This is to certify that CITY OF PORTLAND/Tumer Construction Company/Philip Colem  
has permission to Airport Terminal- 3-Story Steel frame terminal w/ selective demolition connecting to existing terminal & Parking  
AT 947 Westbrook St CBL 199 A001002

Subject: Application ID: 2008-0137

Proposed Project Description:  
Airport Terminal- 3 Story Steel frame terminal w/ selective demolition connecting to existing terminal & Parking Garage

Level 2 Plan (Ticketing Hall and Baggage Make-up Room)

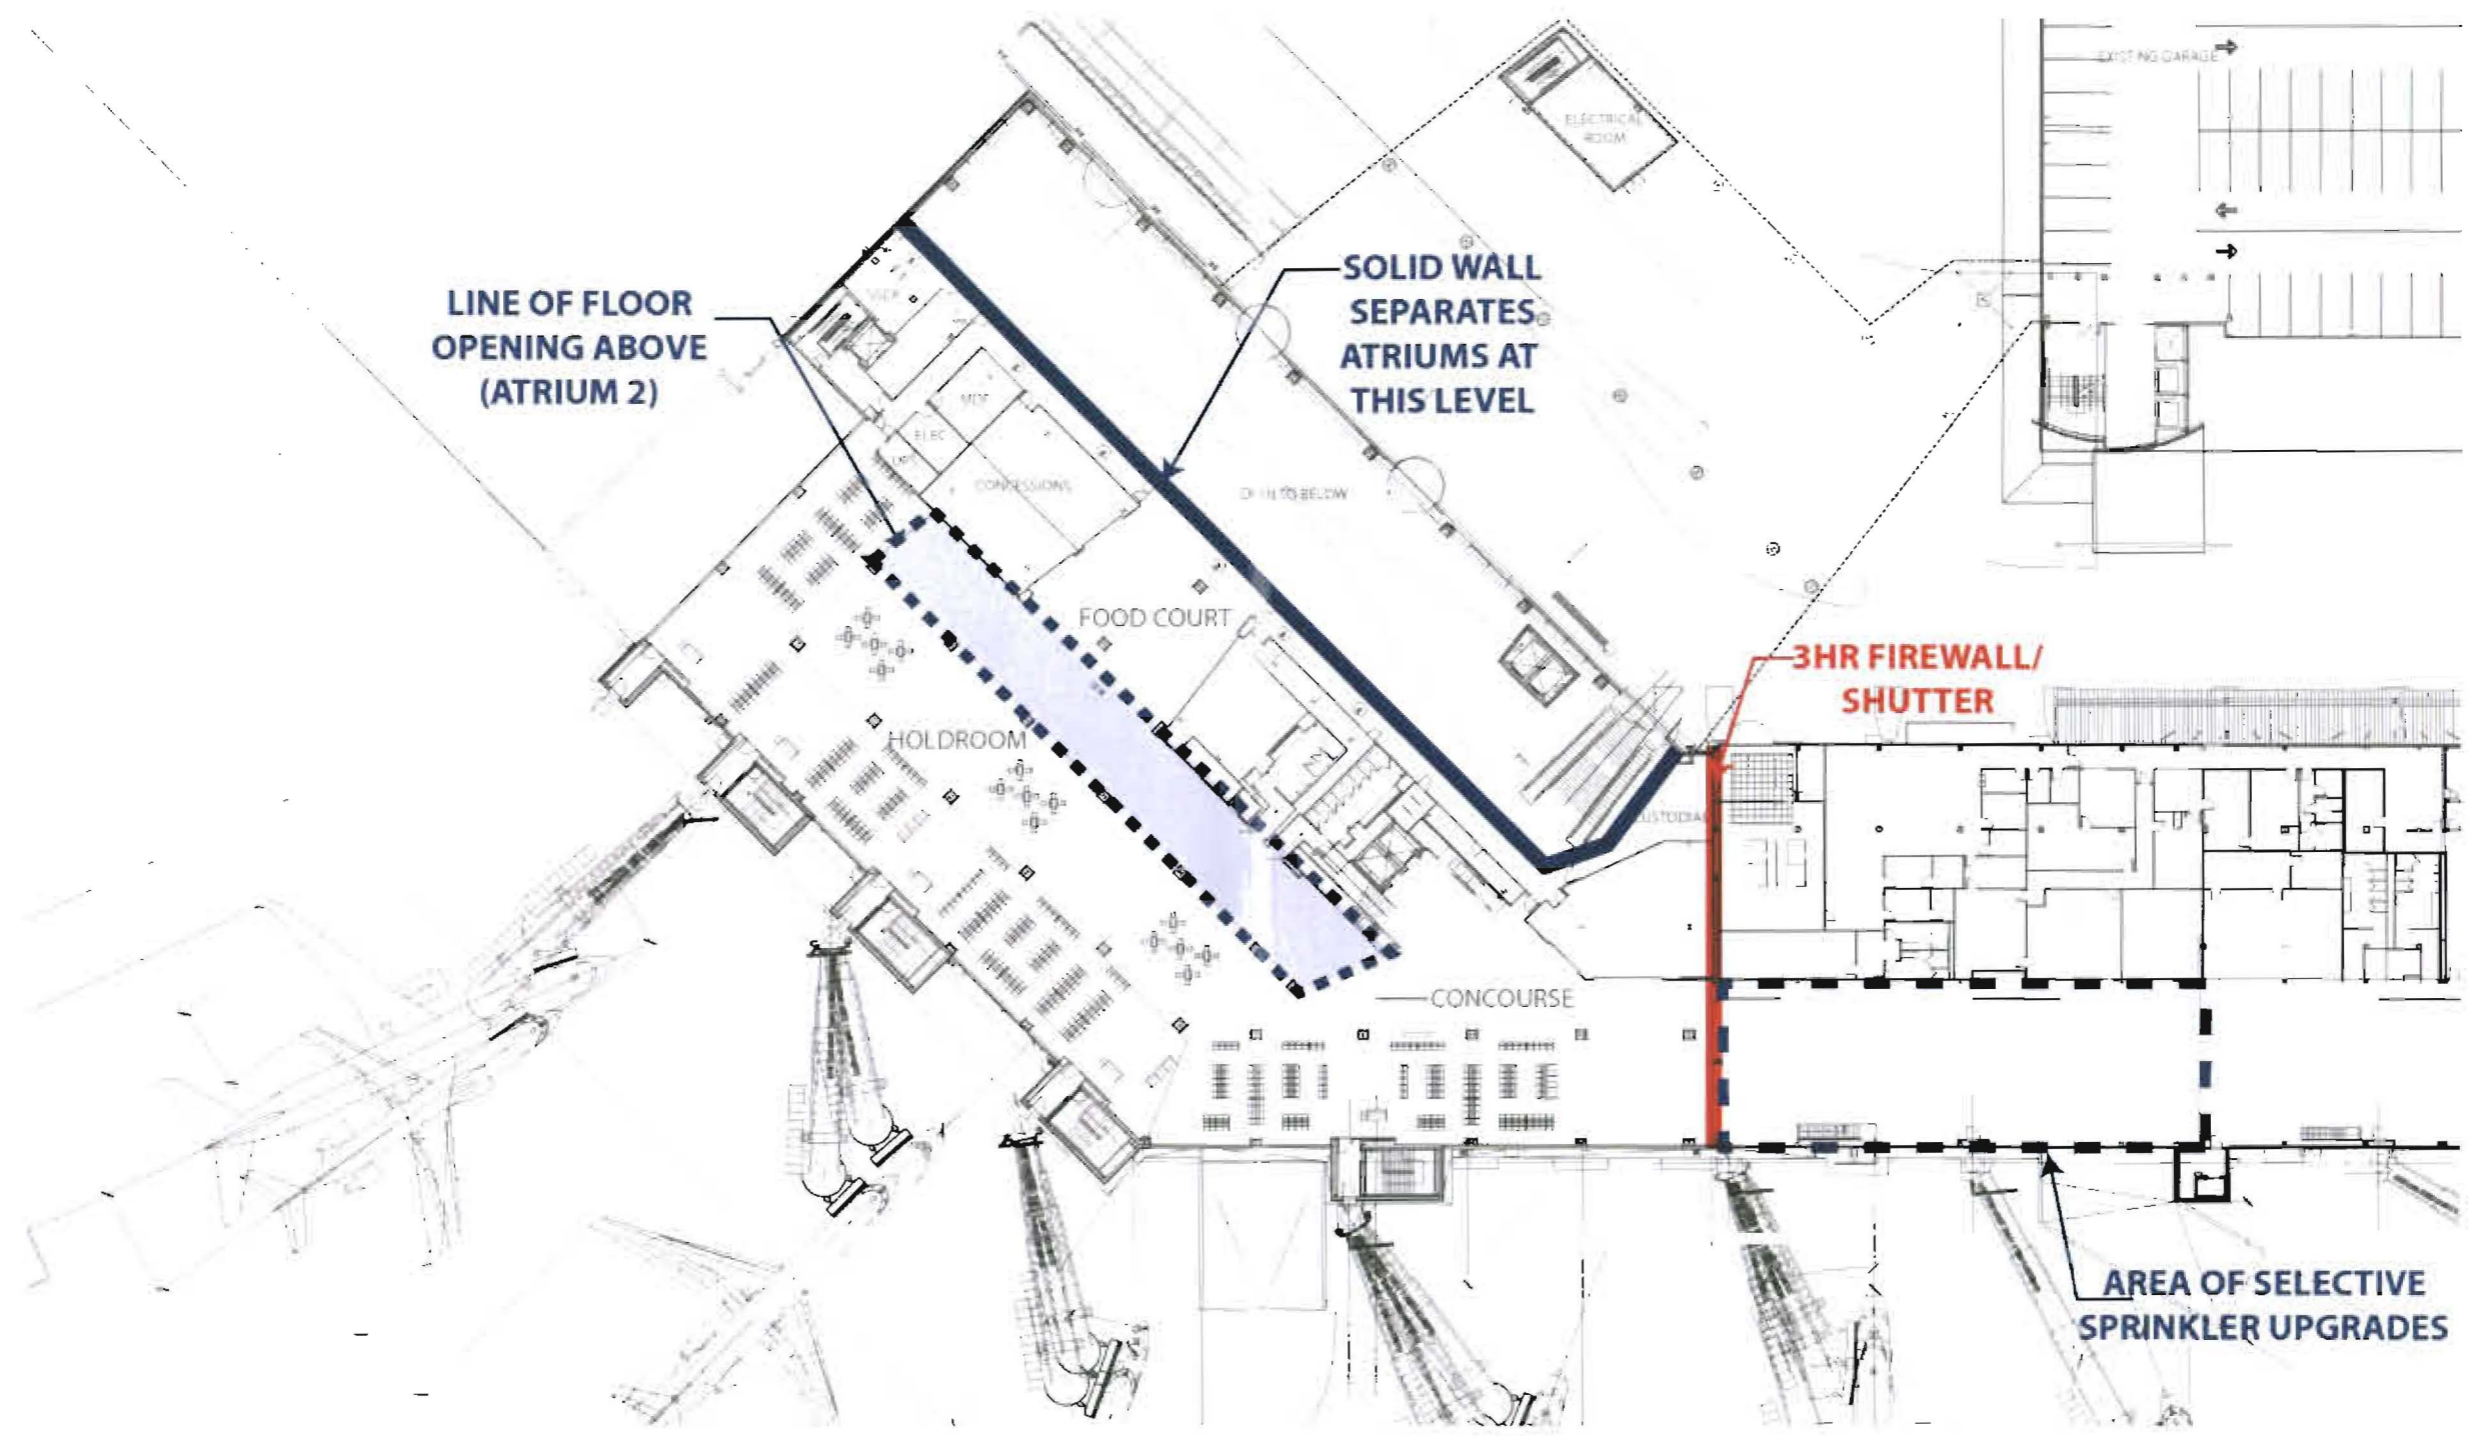
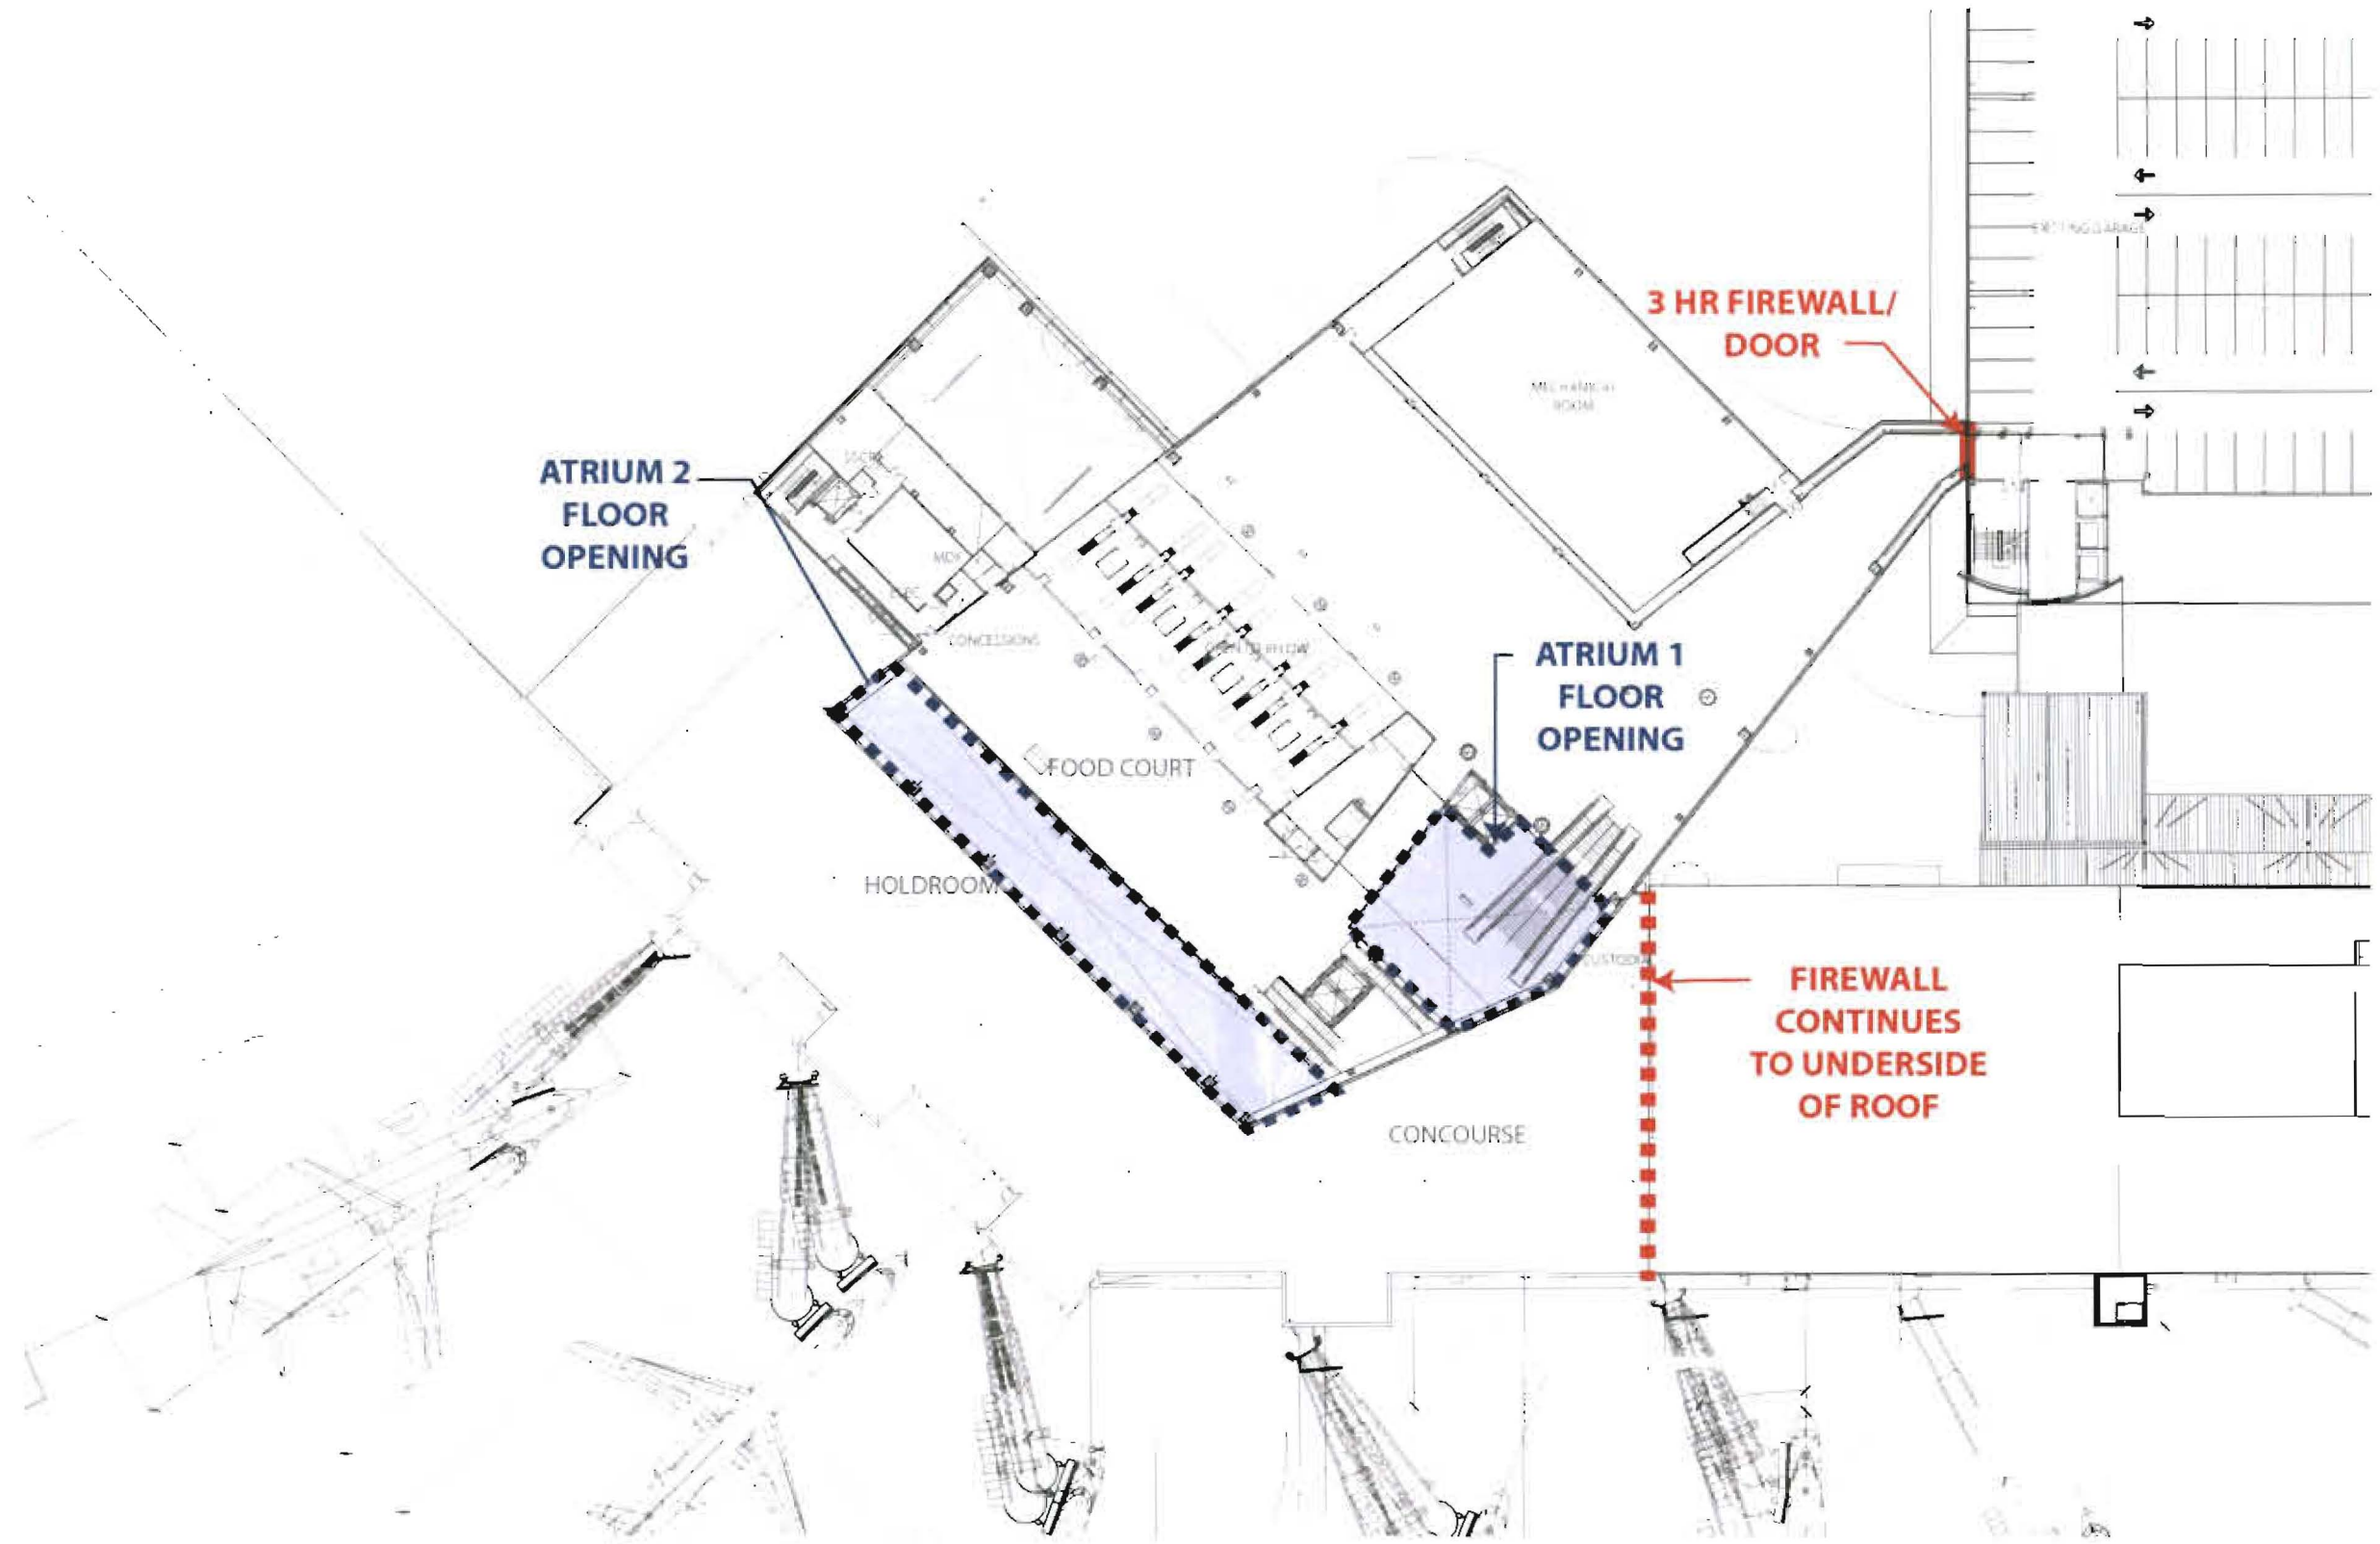
We are requesting approval to reference the IBC 2009 edition for the smoke control exception only. Considering that codes are continually updated to reflect improved testing, building sciences research and real-world building performance, we believe that this does not compromise life safety. Additionally, when the terminal addition is complete in 2012, the IBC 2009 edition may be the applicable code, if adopted by the City of Portland as currently planned. Floor plans and views of the two atriums are included as attachments 4 through 7.
